Access Compliance Report Public Rights-of-Way (Curb Ramps)

Main Street: THORNHILL_ST		Cross Street: BENJAMIN_DR		Location:	W
ADA ID: RPRK211020135432	Ramp Type: Blended Transition 2	Initial Pass/Fail: Fail	Overall Compliance: No	Severity Score:	30
Codes/Mitigation Info/Possible Solution			Field Measurements/Component Compliance

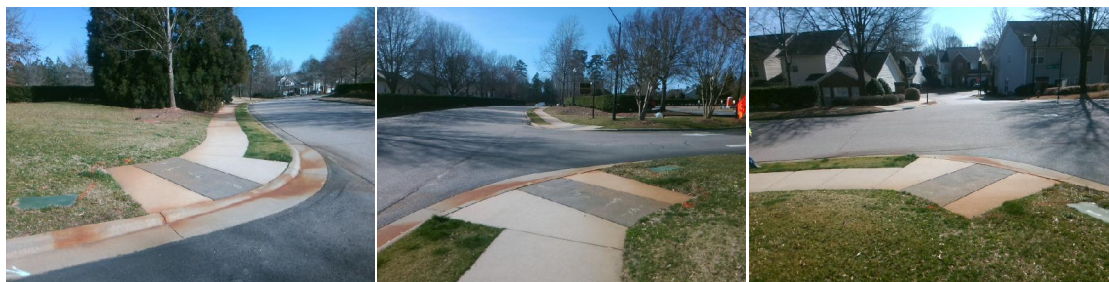
Compliance	Description	Data	Compliance	Description	Data
N/A	Ramp Length (in)	118	N/A	Flare Slope LT (%)	N/A
Yes	Ramp Width (in)	87	N/A	Flare Traversable LT	N/A
Yes	Ramp Run Slope (%)	5	N/A	Flare Slope RT (%)	N/A
No	Ramp Cross Slope (%)	9.6	N/A	Flare Traversable RT	N/A
N/A	Landing Present	N/A	N/A	DWS Provided	N/A
N/A	Landing Length (in)	N/A	N/A	DWS Contrast	N/A
N/A	Landing Width (in)	N/A	N/A	DWS Length (in)	N/A
N/A	Landing Run Slope (%)	N/A	N/A	DWS Full Width	N/A
N/A	Landing Cross Slope (%)	N/A		DWS Offset Type	N/A
N/A	Landing Movement Obstructed?	N/A	N/A	DWS Offset Left (in)	N/A
	Landing Movement Type	N/A	N/A	DWS Offset Right (in)	N/A
N/A	Landing Shared	N/A			
N/A	Clear Space	Yes			
N/A	Clear Space To Crosswalk (in)	N/A			
N/A	Marked Crosswalk 1	No	N/A	Marked Crosswalk 2	No
	Crossing 1 Direction	E		Crossing 2 Direction	N
	Marked Crosswalk 1 Width (in)	N/A		Marked Crosswalk 2 Width (in)	N/A
N/A	Ramp Inside Crosswalk 1	N/A	N/A	Ramp Inside Crosswalk 2	N/A

Remove & Replace Curb Ramp With Two New Directional Ramps or Equivalent.

R204.3, R304.5.3, STD 1115
